37/03-04DDD 7332 Piney Branch Takoma Park Historic District

TO:	James A. Welu (811 Thayer Avenue) for 7332 Piney Branch Road, Takoma Park Historic District
FROM:	Tania Georgiou Tully, Senior Planner Historic Preservation Section
SUBJECT:	Historic Area Work Permit Application # 356161

HISTORIC PRESERVATION COMMISSION STAFF REPORT

Address:	7332 Piney Branch Road	Meeting Date:	10/13/04
Applicant:	James A. Welu	Report Date:	10/06/04
Resource:	Outstanding Resource Takoma Park Historic District	Public Notice:	09/24/04
		Tax Credit:	No
Review:	HAWP		
Case Number:	37/03-04DDD	Staff:	Tania Tully

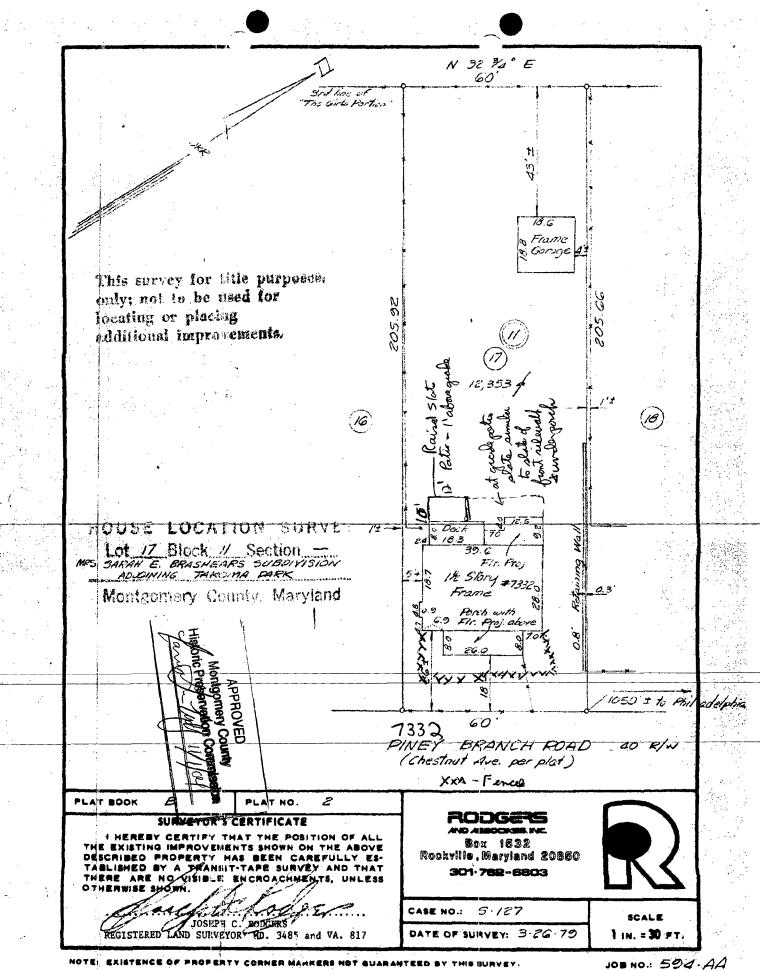
APPROVED the set overhaug (1) TZZZ Montgomery County Historic Preservation Commission 2 3 3 ß 33 3 3 3 13 13 5 3 one foot E overhang beaded board will be back onto roof rafters as required to give maximum support roofrafters 7332 Pinen Biko showing Voverhangatrean Tab. Pack me E areas - Beaded board To show on all averhang arean bolarce of roof deck in plywood 7332 Percy B. Ro Tobura Park Md Wala

Revised Proposal Dormer - Shed Roof styl 733 & Piney Bu Rd Jahoma Park md

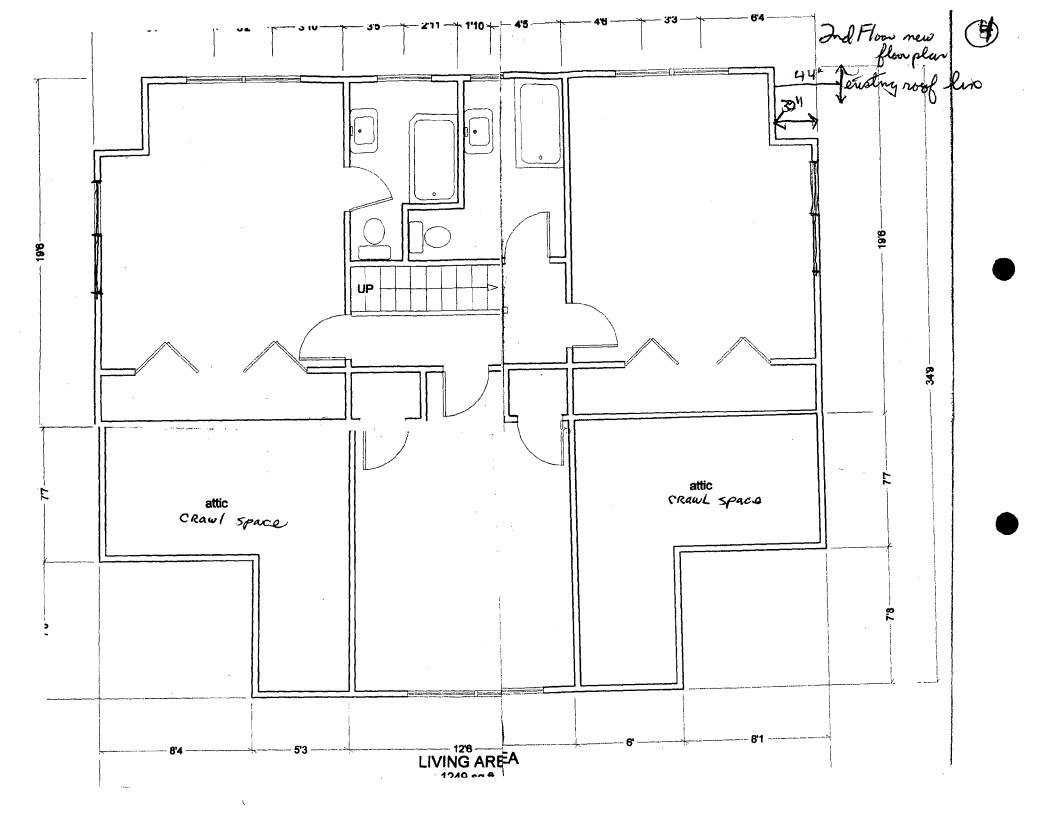
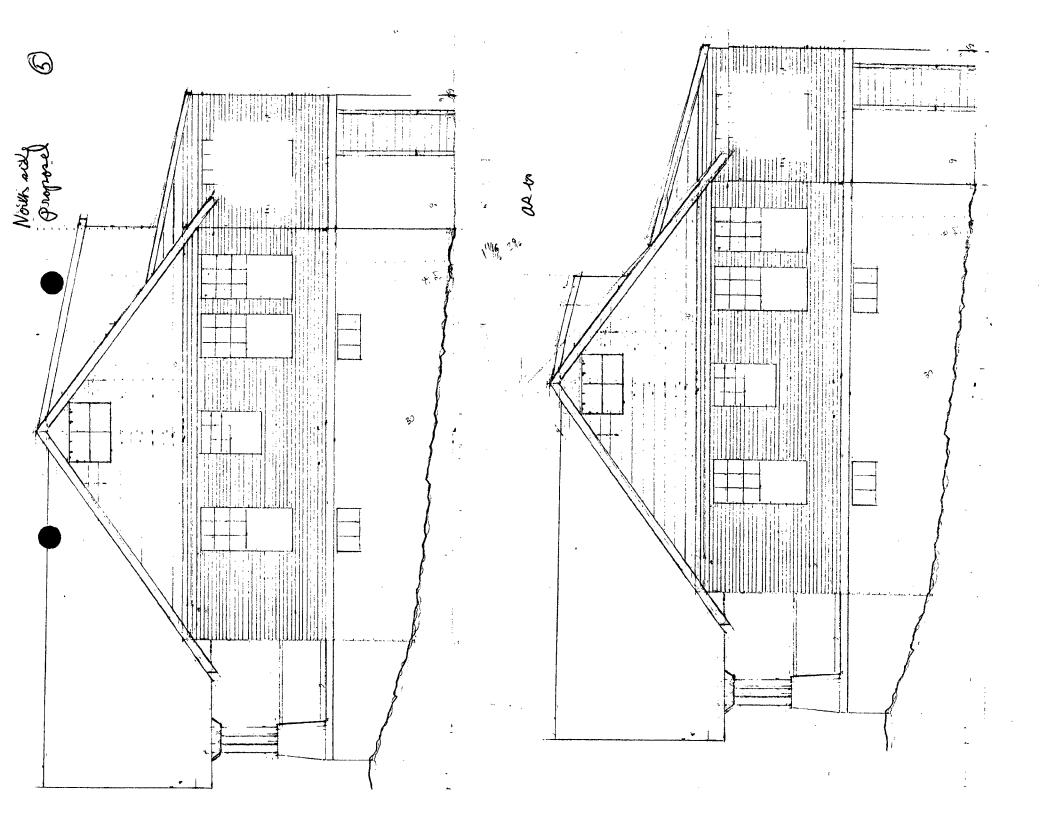
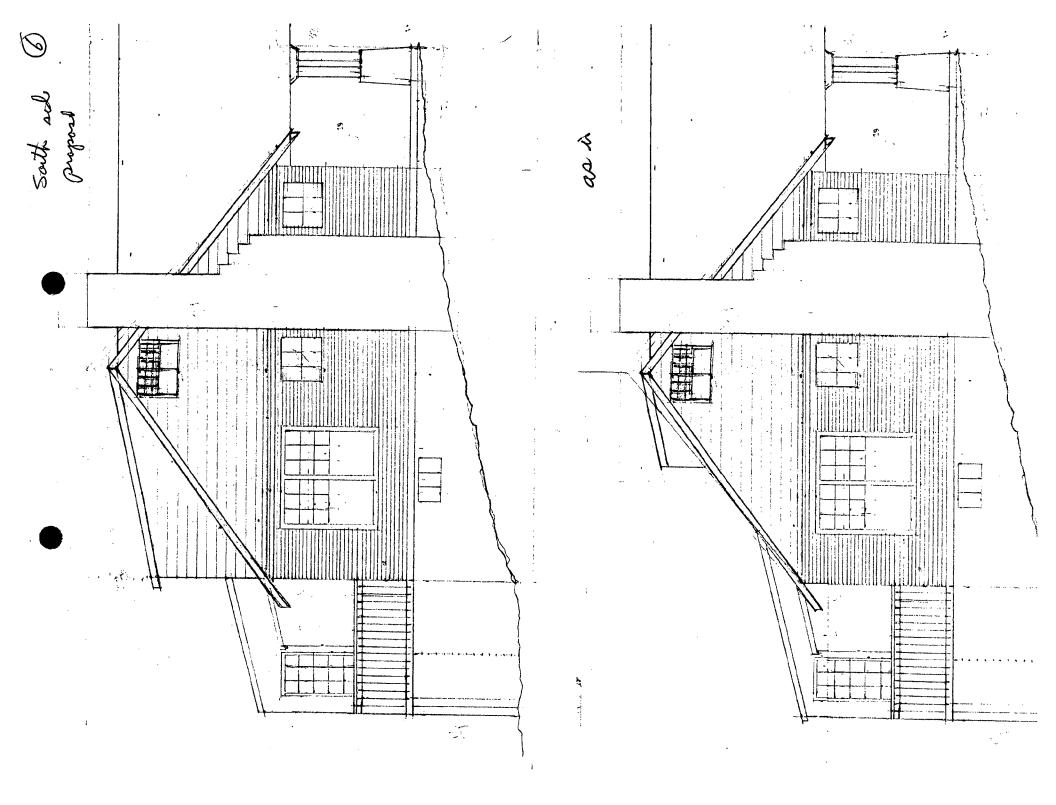
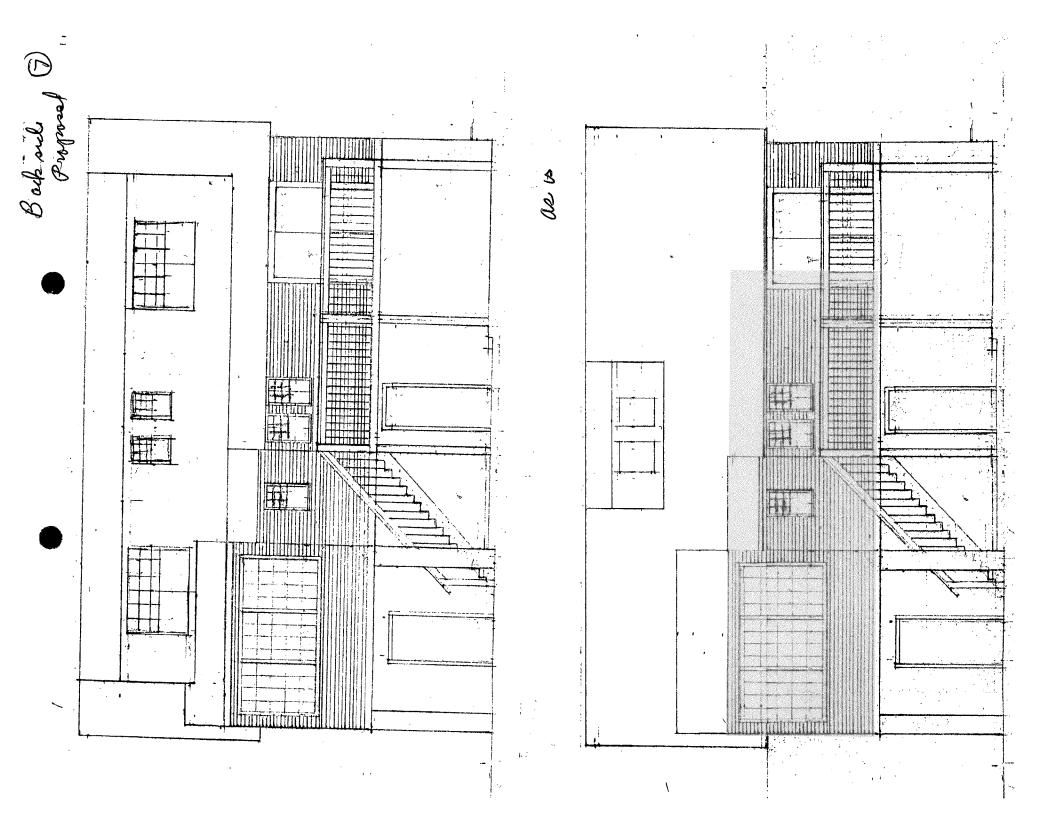
As suggested by the Commission, the applicant redesigned the proposed dormer. The pitch of the roof appears to be the same as the existing dormer and it has been inset 44" from the sides of the roof. The Applicant also provided an illustration of "The Wareham," a catalog house with a dormer similar to the proposal in form (Circle 14). Unfortunately, the drawings provided do not indicate any detailing that would make the dormer more compatible with the house. Staff suggests that the applicant widen the eaves of the dormer and/or add decorative rafter ends in order to be more sympathetic with the historic house.

- The casement windows are retained; fry Y Windows Windows Appropriate design details are added to the dormer design;
- 3. Windows in the new dormer are wood or clad-wood with true or simulated divided lights:

- 1. Appropriate design details are added to the dormer design;
- 2. Windows in the new dormer are wood or clad-wood with true or simulated divided lights;
- 3. Applicant is to work with staff to determine if retention of the sunroom windows is feasible; if not, the new windows should visually match the existing as closely as possible and will be approved by staff.

Revised Proposal Dormen - Shed Roof styl 733 2 Piney Bu Ro Jahoma Park md

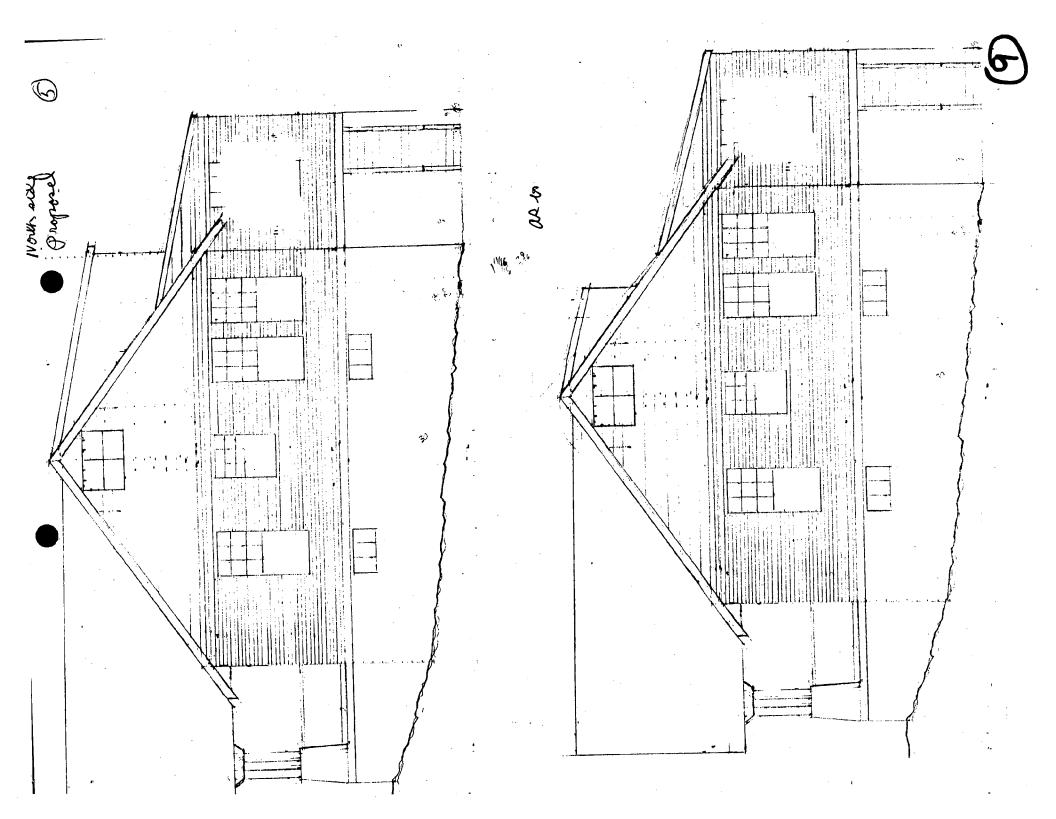
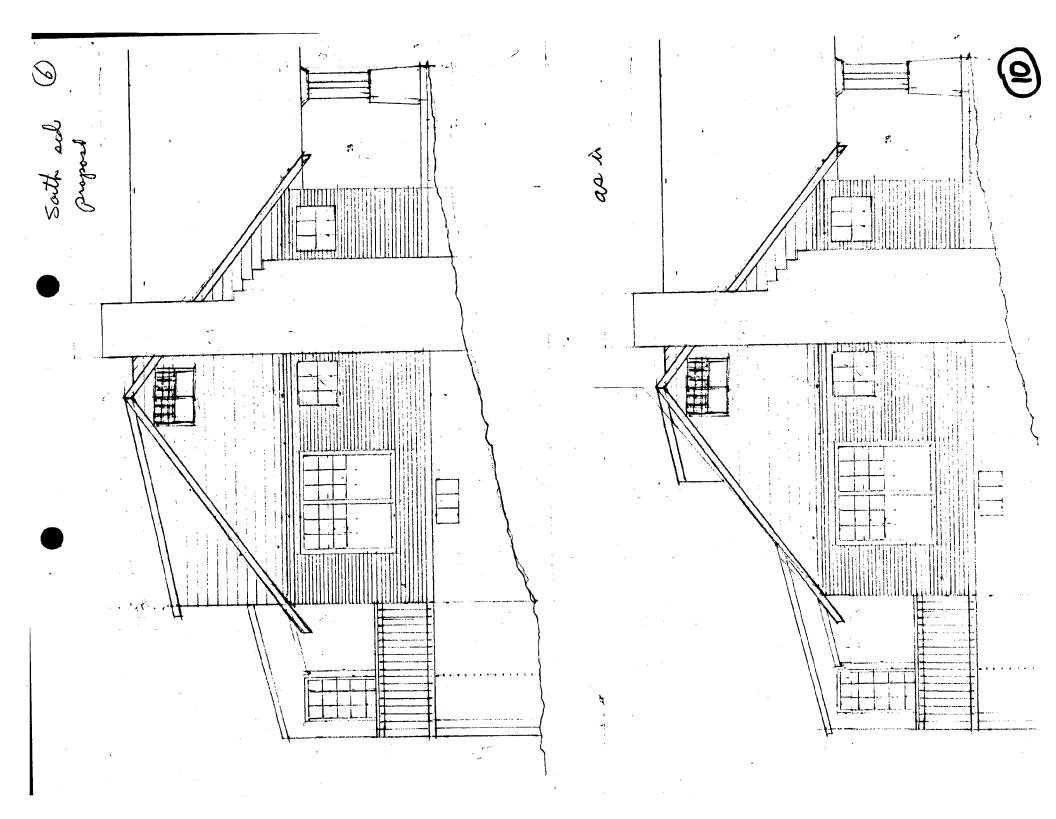
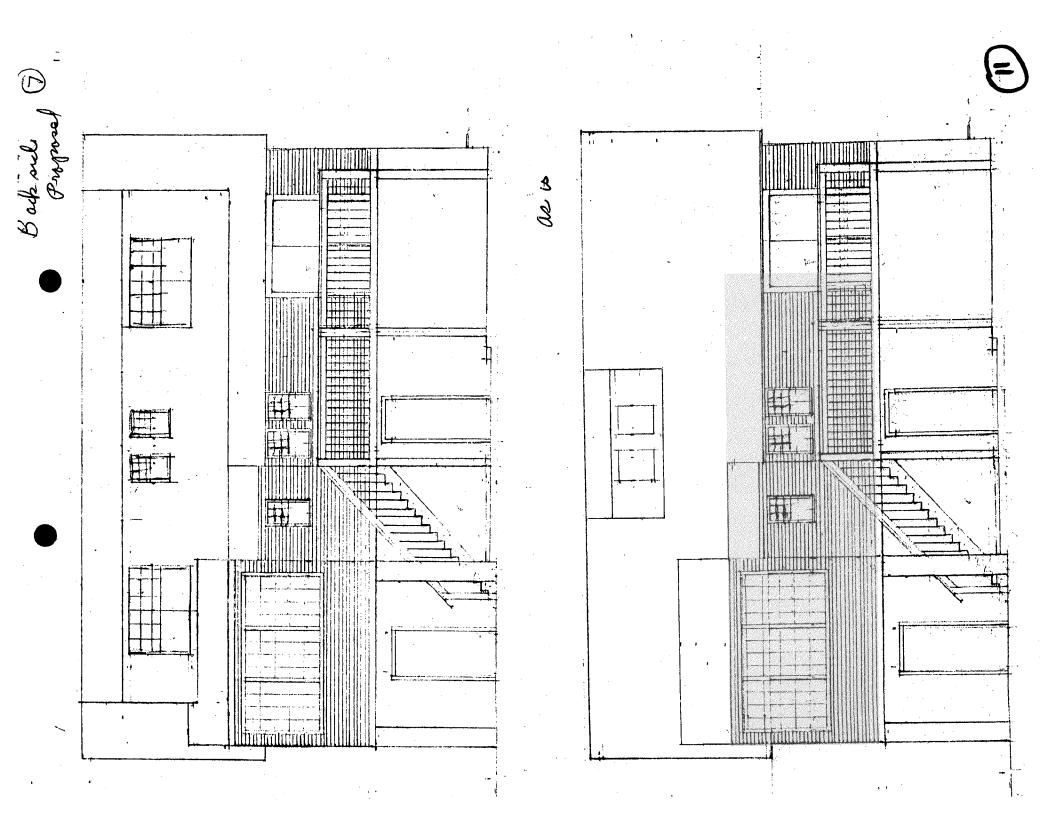
As suggested by the Commission, the applicant redesigned the proposed dormer. The pitch of the roof appears to be the same as the existing dormer and it has been inset 44" from the sides of the roof. The Applicant also provided an illustration of "The Wareham," a catalog house with a dormer similar to the proposal in form (Circle 14). Unfortunately, the drawings provided do not indicate any detailing that would make the dormer more compatible with the house. Staff suggests that the applicant widen the eaves of the dormer and/or add decorative rafter ends in order to be more sympathetic with the historic house.

- 1. The casement windows are retained;
- 2. Appropriate design details are added to the dormer design;
- 3. Windows in the new dormer are wood or clad-wood with true or simulated divided lights;
